MEETING:	PLANNING AND REGULATORY COMMITTEE
DATE:	17 JANUARY 2024
TITLE OF REPORT:	<p>163932 - OUTLINE PLANNING APPLICATION FOR A SUSTAINABLE URBAN EXTENSION COMPRISING: UP-TO 250 DWELLINGS; OPEN SPACE, ALLOTMENTS AND LANDSCAPING; SCHOOL EXPANSION LAND; AREAS OF CHILDREN'S PLAY; SUSTAINABLE URBAN DRAINAGE INFRASTRUCTURE; INTERNAL ROADS; AND ASSOCIATED INFRASTRUCTURE. DETAILED APPROVAL IS SOUGHT FOR PRINCIPAL MEANS OF ACCESS AND LAYOUT WITH ALL OTHER MATTERS RESERVED AT LAND AT HARDWICK BANK, BROMYARD, HEREFORDSHIRE,</p> <p>For: Vistry Homes Limited and Mosiac Estates per Russell Smith, McLoughlin Planning, 119 Promenade, Cheltenham, GL50 1NW</p>
WEBSITE LINK:	https://www.herefordshire.gov.uk/info/200142/planning_services/planning_application_search/details?id=163932&search-term=163932
Reason Application submitted to Committee - Redirection

Date Received: 7 December 2016 Ward: Bromyard West Grid Ref: 364358,254665

This application seeks outline planning permission to develop land at Hardwick Bank, Bromyard for up-to 250 dwellings. The application also seeks approval of the layout and means of access. It is a substantive revision of the original iteration deposited in 2017 which was

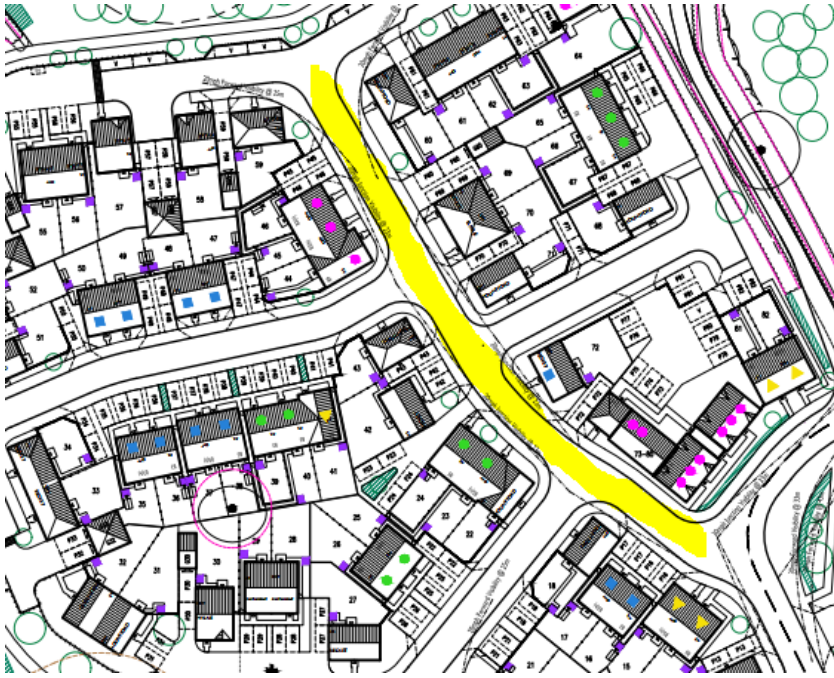
The LHA require visibility splays of 2.4m x 33m to be provided at all junctions along the spine road through the site, this is commensurate with speeds of 25mph. The applicant has agreed that these are appropriate, however, the visibility splays demonstrated on the plans provided are incorrectly drawn. For example, below is a screenshot of one of the visibility splays. As can be seen the x distance does not appear to be 2.4m (for context the footway/cycleway at the junction is 3m wide and the visibility splay x distance should be setback 2.4m from the give-way line). The x distance appears to sit on the give-way line rather than being setback 2.4m.

Another example is given below, not only is the x distance not 2.4m it isn't even taken from the centre of the junction.

These are concerns that have been raised on a number of occasions with the applicant, however, the applicant has been unwilling to amend them. The only avenue available to get the splays rectified is to add their correct provision as a condition of planning consent, especially given that the LHA is unable to adopt the roads within the site.

1. A plan demonstrating visibility splays of 2.4m x 33m with the splay being delineated by the back of the footway at all junctions should be provided prior to commencement on site for the approval by the LHA/LPA. Nothing over 0.6m in height should be placed within the splays. This condition overrides the visibility splays demonstrated on drawing 0687-102.

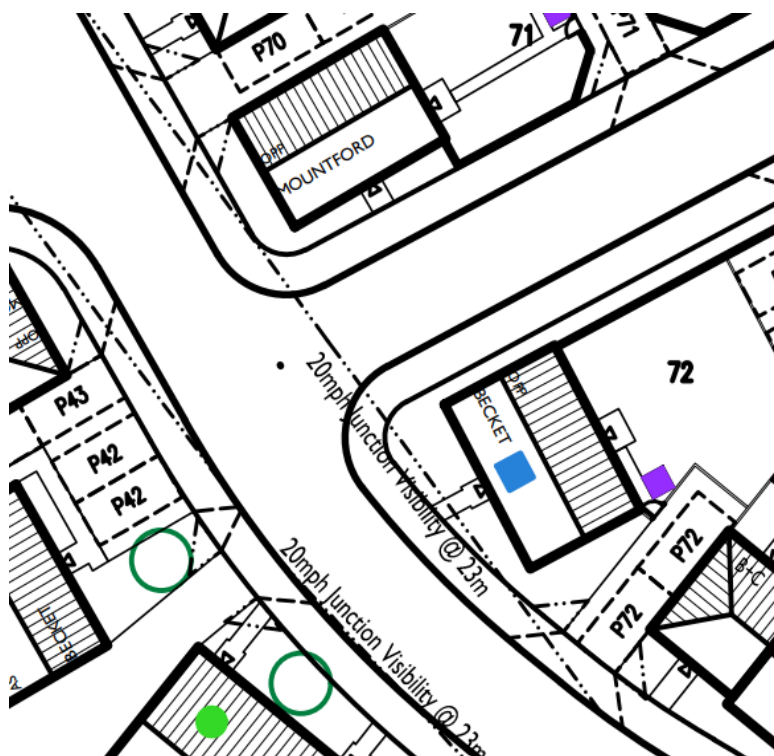
Another issue concerning visibility splays is the length of the splays on the side roads. The applicant has provided splays of 2.4m x 23m. However, splays of this length are for streets which serve lower numbers of dwellings, are constrained in width and do not have a straight alignment. The below screenshot shows one of the roads where 23m visibility splays are provided, the road is wide at 5.5m and of a reasonably straight alignment, therefore the ability to constrain speeds is limited due to its geometric features.

Our Highway Design Guide for New Developments states that for roads which serve between 25 and 100 dwellings (the above example serves 66 dwellings) should be 5.5m in width, as the above example is, and have visibility splays of 33m. Therefore visibility splays of 2.4m x 33m have been requested on a number of occasions, however, the applicant has been unwilling to provide them.
